Technical Evaluation Report

Draft Waste Incidental to Reprocessing
Evaluation for Vitrified Low-Activity
Waste Disposed Onsite at the
Hanford Site, Washington

Final Report

U.S. Nuclear Regulatory Commission
Office of Nuclear Material Safety and Safeguards
Washington, DC 20555-0001

Figure 4-5 Vertical Cross Sections of Engineered Features Represented in Performance Modeling of the IDF
 [Figure 2-3 of (RPP-CALC-61029, 2017)]

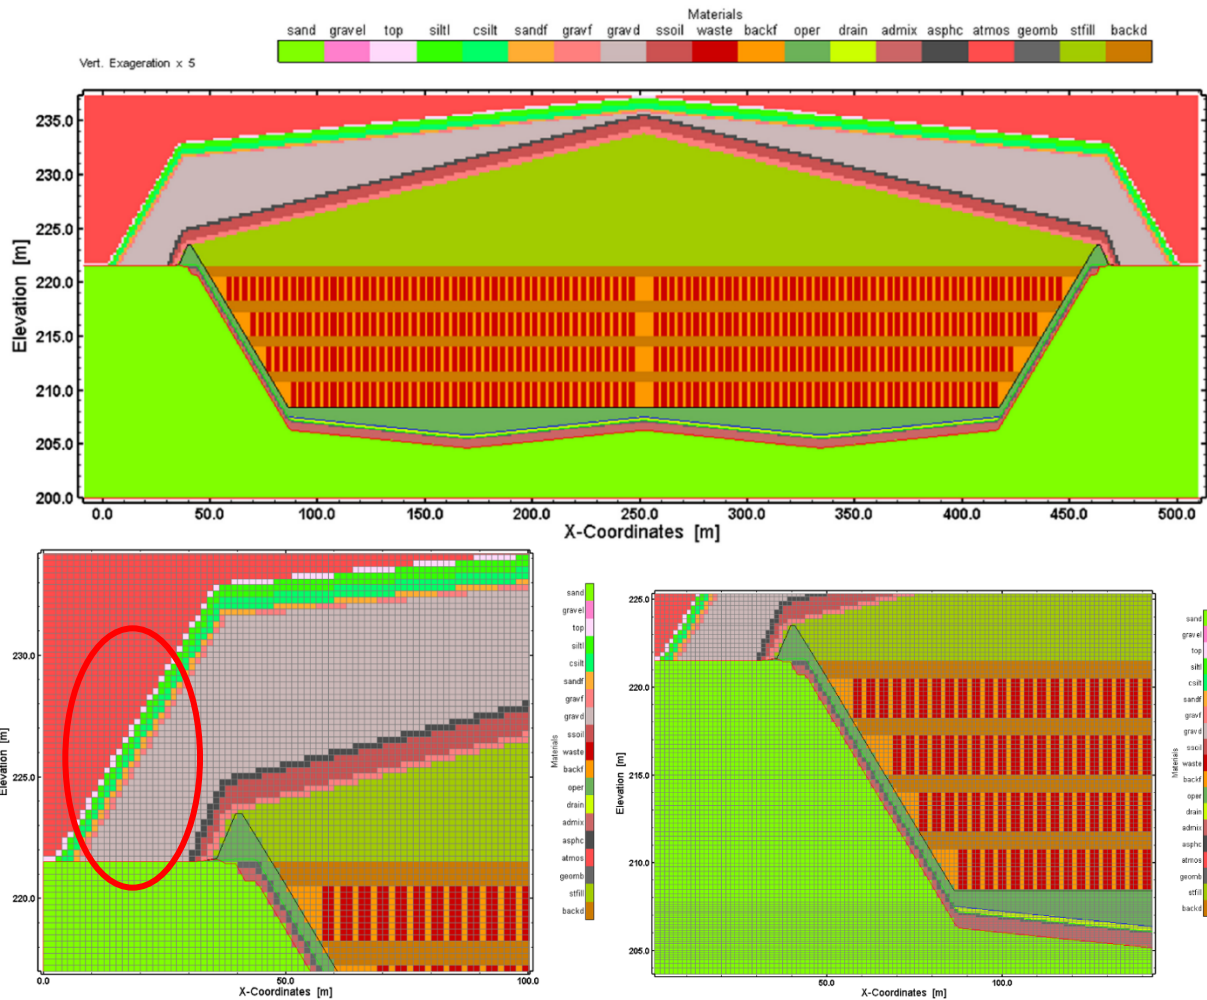
domain that DOE needed to simulate was quite large (thousands of cubic meters), whereas some of the material layers are designed to be quite thin (scale of centimeters). As shown in Figure 4-5, the discretization of some of the layers in the numerical model was not continuous (shown outlined in red oval).

DOE acknowledged the discontinuities in the layers in the model but stated that the near-field hydrology modeling was used to define boundary conditions for the wasteform release and transport modeling. The near-field flow model was used to develop estimates of saturations in the backfill and wasteforms in the absence of long-term data and to evaluate the distribution of moisture movement into the vadose zone in the presence of an intact and a degraded liner system. The NRC staff believes it is unlikely that the artifacts DOE introduced by the discretization of the surface barrier significantly impacted the boundary conditions for the wasteform release modeling. The distance from the modeling artifacts in moisture distributions and flow to the waste is generally many meters, allowing time/space for the artifacts to be reduced. The amount of water reaching the glass wasteform and the amount of water flowing through the cracked glass wasteform were substantially different. If the magnitude of the diversion of water was sensitive to the boundary conditions, then the discontinuities in the overlying layers could be significant. It is recommended that DOE evaluate if the numerical grid used was sufficient and eliminate numerical modeling artifacts to the extent possible in future evaluations (Recommendation #4).

Figure 4-11 Partitioning of Select Volatile Radionuclides Among Wasteforms for Different Inventory Cases

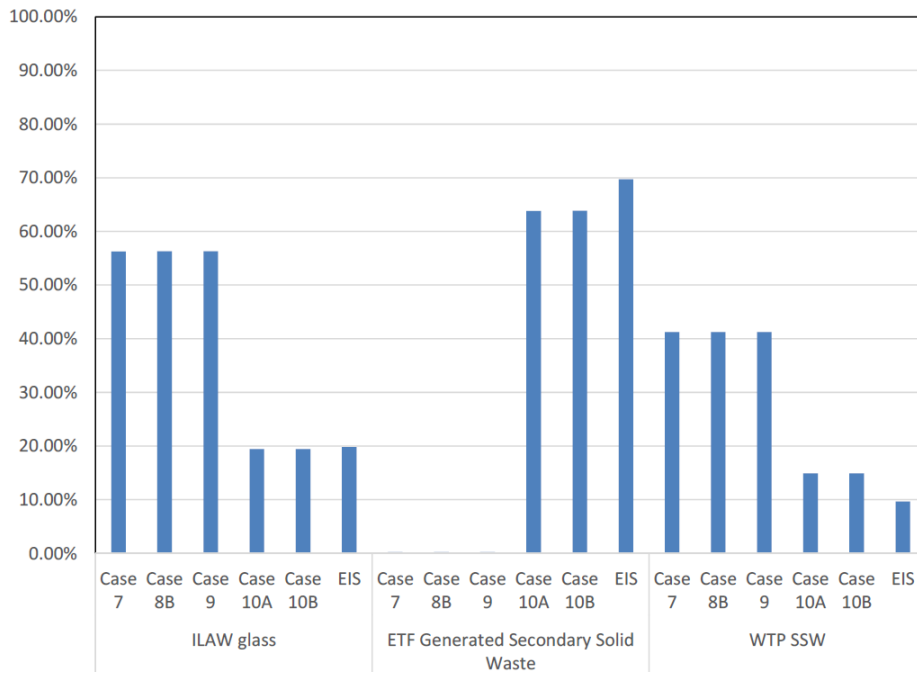
DOE identified the amount of volatile species that partition between different wasteforms (i.e., glass or non-glass) as a key uncertainty. The NRC staff agrees that the partitioning of volatile species between wasteform types is a key uncertainty. In the IDF PA, DOE evaluated different inventory cases. Figure 4-11 shows the disposition of two volatile radionuclides (^{99}Tc and ^{129}I) for the different inventory cases. DOE stated that the inventory cases produced small doses in the 1,000-year compliance period (well below the performance objective). However, peak doses from options 10a and 10b were much higher than other alternatives and exceeded the performance objective in the sensitivity and uncertainty analysis period. Doses from Case 7b were also higher than the remaining cases and were close to the 0.25 mSv/yr (25 mrem/yr) protection of the public performance objective in the sensitivity and uncertainty analysis period.

Figure 4-13 Fractional and Cumulative ⁹⁹Tc Release Rates from HEPA Filter Cement Wasteforms

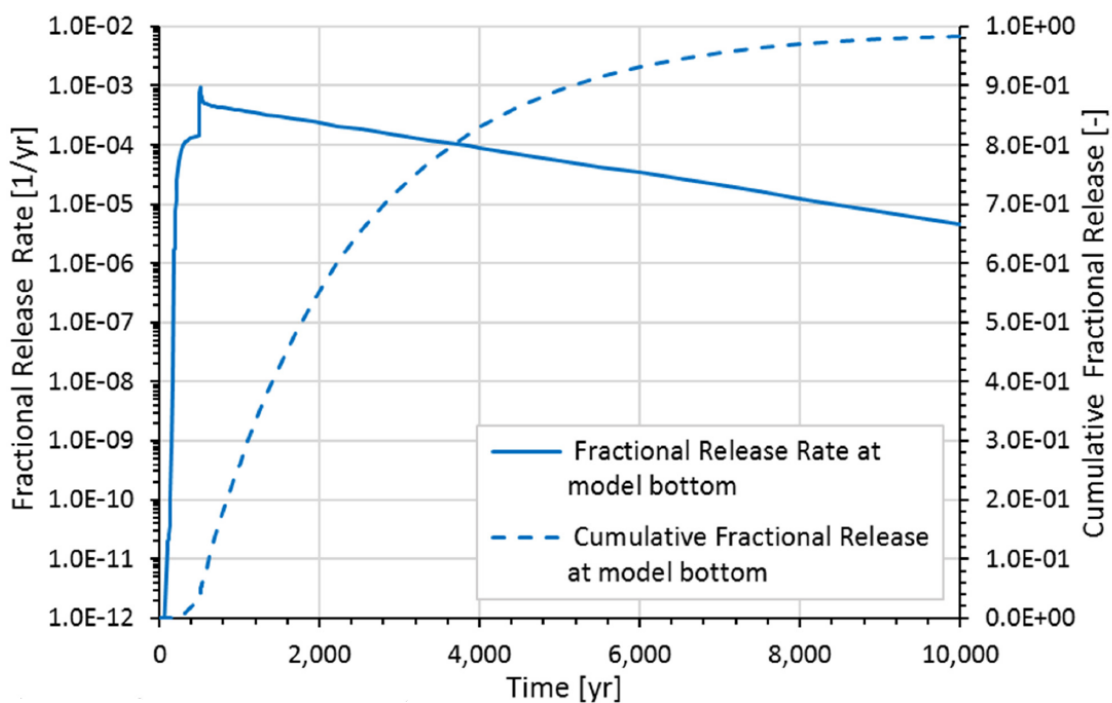
As shown in Figure 4-13 for SSW-HEPA, the releases from cementitious wasteforms were characterized by a rapid increase up until shortly before 500 years, followed by a spike at 500 years, with a rapid and then gradual decline. The magnitude of the estimated releases were consistent with the parameters and models used. The early shape of the release curves is likely to be more a function of assumptions made by DOE rather than a physical result. DOE elected to take a pessimistic (conservative) approach to representing some engineered features of the system.
